Staff Report

To: BOZAR
From: Jessie Earley, Senior Planner
Meeting Date: DRC, January 12, 2026
RE: 31 Augusta Drive, Secondary Review

PROJECT TITLE: Augusta Park Partners LLC (31 Augusta Drive)

SUMMARY: Consideration of the application of **Augusta Park Partners LLC** to site a single-family residence and a cold accessory building to be located at 31 Augusta Drive, Lot T4, Slate River Subdivision in the R1F zone.

Residence:

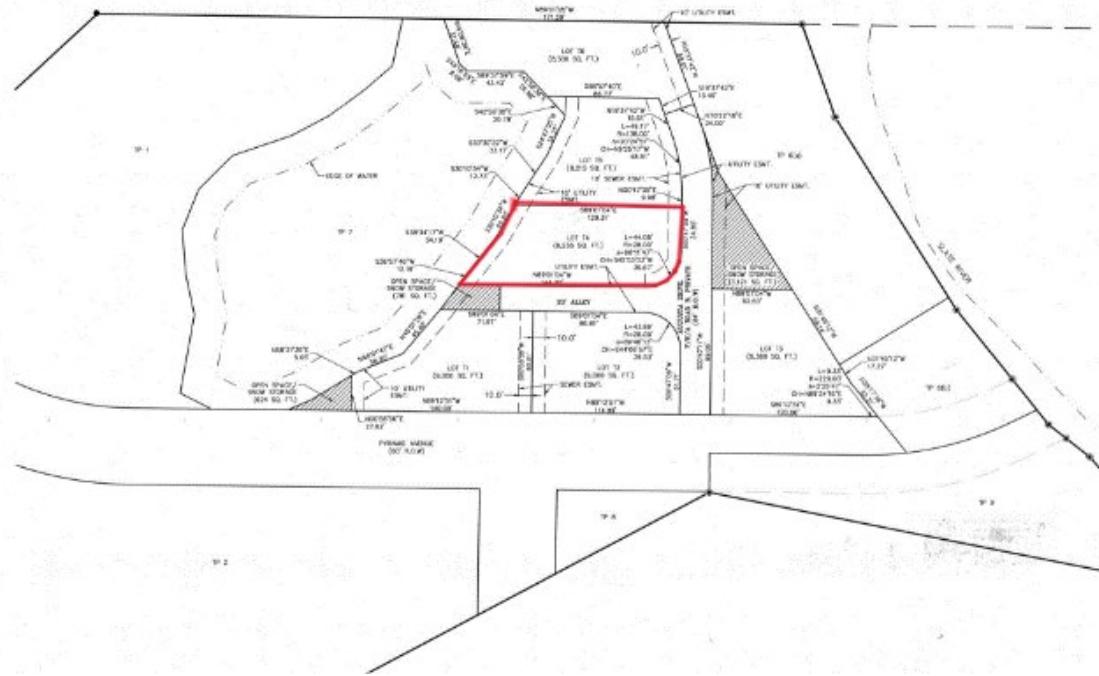
- -Material Changes:
- --Vertical Siding = 8" Reclaimed Light Brown
- --Stone Siding = Light Brown
- --Trims = Painted Revere Pewter
- --Windows = Painted Revere Pewter
- --Roof = Dark Bronze
- -Chimney element breaks roof plane.
- -The East roof peak raised.

Proposed Site plan

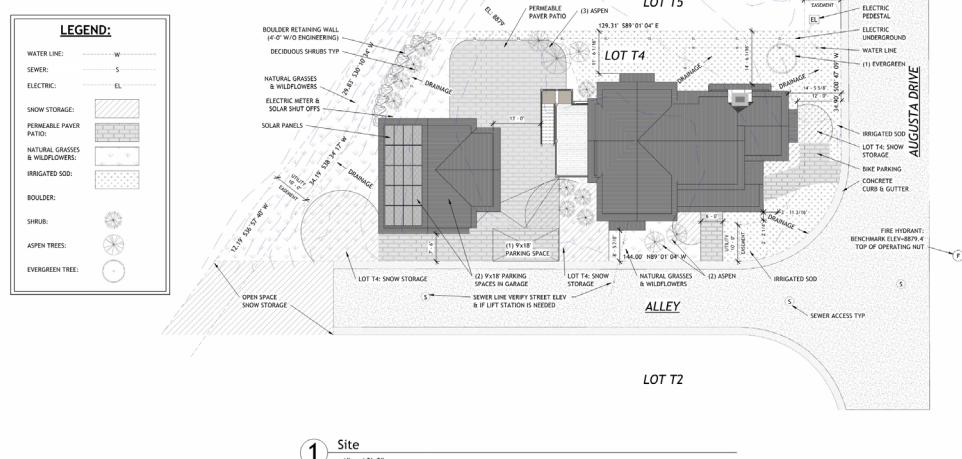
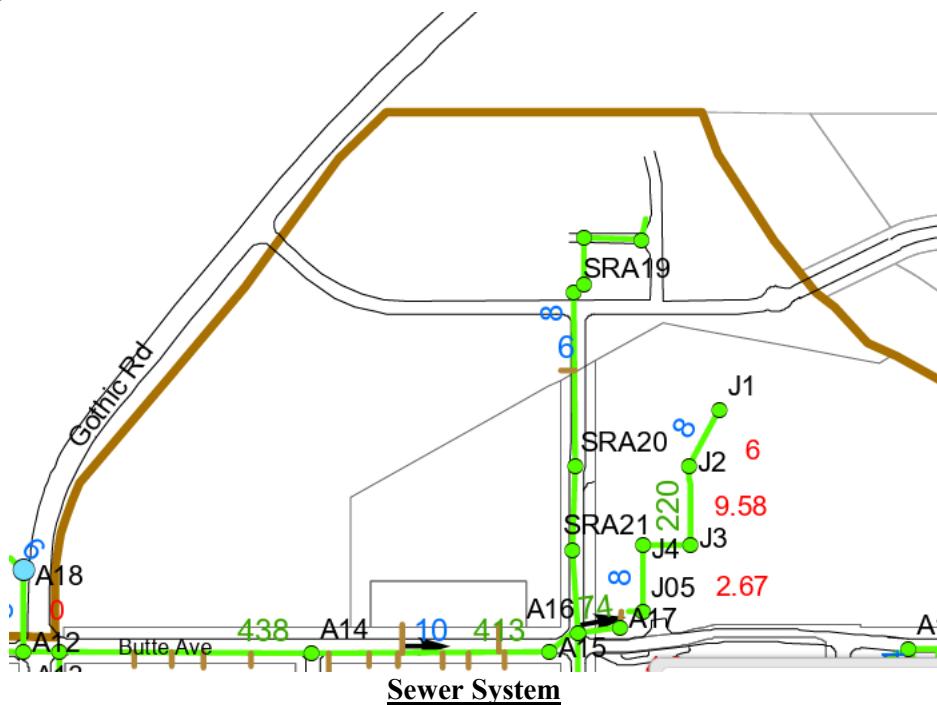
GL	Staff Analysis	DRC Recommendation
Topography	<p>On the northeast corner of the lot, the grade is noted 8875'. This transitions up to 8878' and then back down to 8870' in the southwest corner of the lot.</p> <p>Over the course of the primary building footprint, the grade is 8878'3", which is the elevation used for measuring FAR.</p> <p>For the accessory, the bulk of the grade for measuring FAR is 8877'.</p>	Support

2.8 Drainage	<p>Drainage arrows for the site are shown. With the inclusion of the basement, a dry well onsite will likely be required, but details for this can be coordinated prior to permitting.</p>	Support
Easements	<p>There is a 10' utility easement for the west side and for the east side of the lot. Both are called out on the site plan, as well as a 10' utility easement on the southeastern corner.</p> <p>The trees have been removed from the utility easement on the southeast corner.</p>	Support

2.16 e Pervious materials 2.28 e &f Parking substrate	<p>Walkways and patio (~1918 sf) are called out as permeable pavers. This appears to meet the intent of GL 2.16 e.</p>	<p>12/8 DRC: General support, but further discussion around amount of pavers is encouraged</p>

2.7 Snow Storage	<p>Snow storage is provided and appears to exceed the 33% of areas to be plowed.</p>

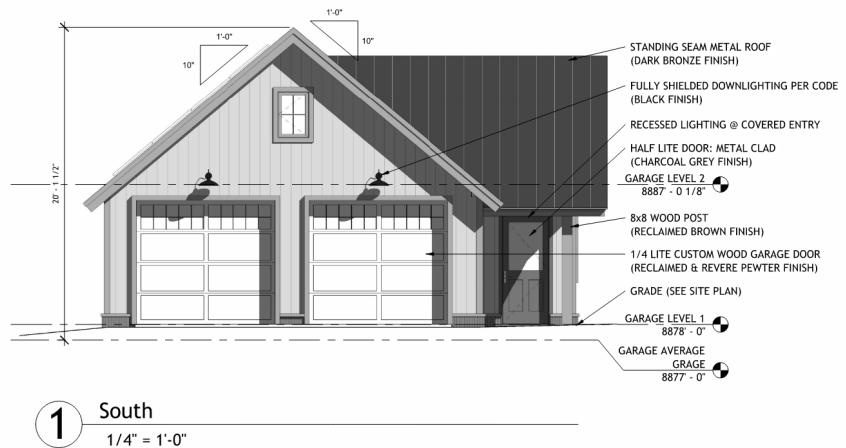
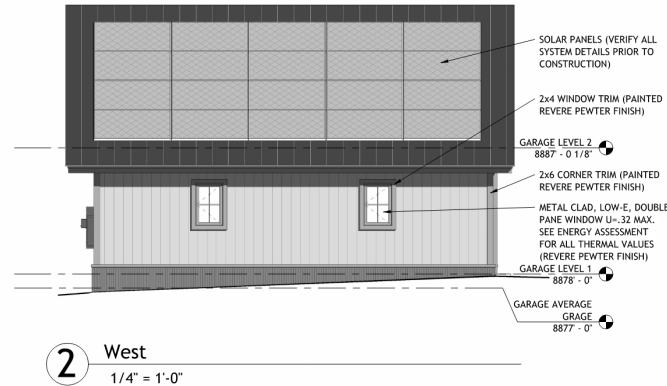
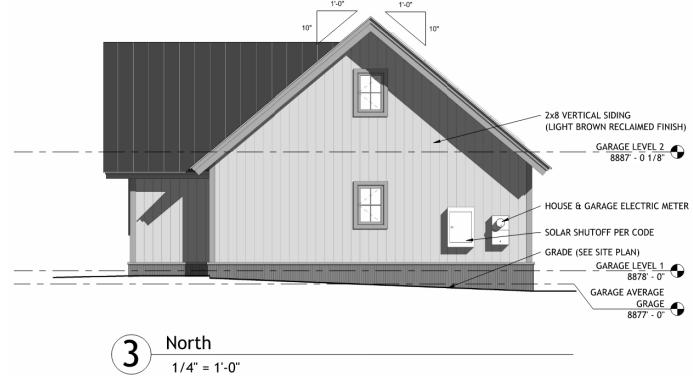
The proposed accessory building is a 24'x28' gable module. Then, there is a 6'x14' gable module to the east. The main module has a 10:12 pitch with a 10:12 gable roof on the east . This must be a cold building due to the size, as proposed.

GL	Staff Analysis	DRC Recommendation
4.84 Smaller in size	The proposed building is smaller in scale than the primary building, as

requested by the GL.	
4.85 Rear of the site	This building is located on the west, which is the rear of the lot. Meets GL.	
4.86 Vary appearance	This is the third accessory building within this zone. The proposed accessory appears to vary in appearance to the prior proposed accessory in the neighborhood.	
4.89 d. porches	There is a small covered porch on the south. Support.
